DUKE POWER COMPANY

March 28, 1983

Re: McGuire Nuclear Station
Docket No. 50-369

Attached are responses to the questions included in the March 17, 1983 letter by Elinor G. Adensam. The questions concerned the proposed Technical Specification change for McGuire Unit 1 to reduce the measurement uncertainty for RCS flow rate. Please note that these responses were discussed with the NRC staff on March 23, 1983. We will be available to meet with the NRC staff to discuss this further, if necessary.

Figure 1

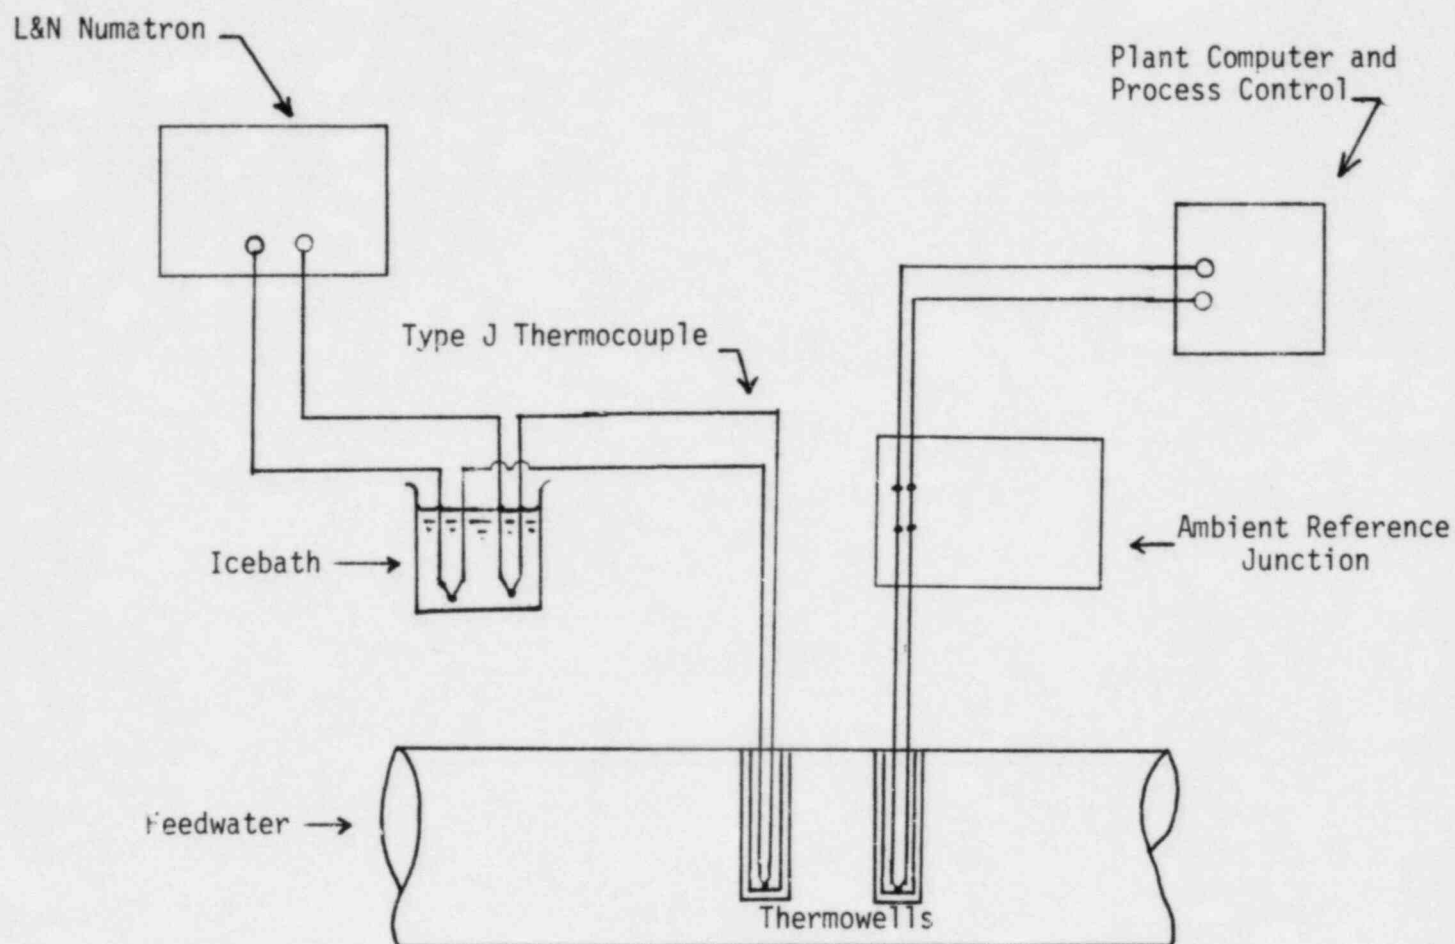
Please further clarify how the feedwater temperature is measured and the basis for its component error.

Each feedwater temperature is measured by precision instrumentation consisting of a continuous-lead type J thermocouple and an icebath reference junction. The feedwater thermocouple output is measured by a Leeds and Northrup 914 Numatron DVM with a 0-40 millivolt range. Refer to Figure 1 for a comparison between process feedwater temperature measurement and precision feedwater temperature measurement. Component uncertainties are as follows:

Thermocouple Calibration $\pm 0.25^\circ\text{F}$
Readout Calibration $\pm 0.03^\circ\text{F}$

$$\text{USL} = \sqrt{\Sigma U_i^2} = \sqrt{(\pm 0.25)^2 + (\pm 0.03)^2} = \pm 0.25^\circ\text{F}$$

$$2 \times \text{USL} = 2 \times 0.25^\circ\text{F} = \underline{0.5^\circ\text{F}}$$
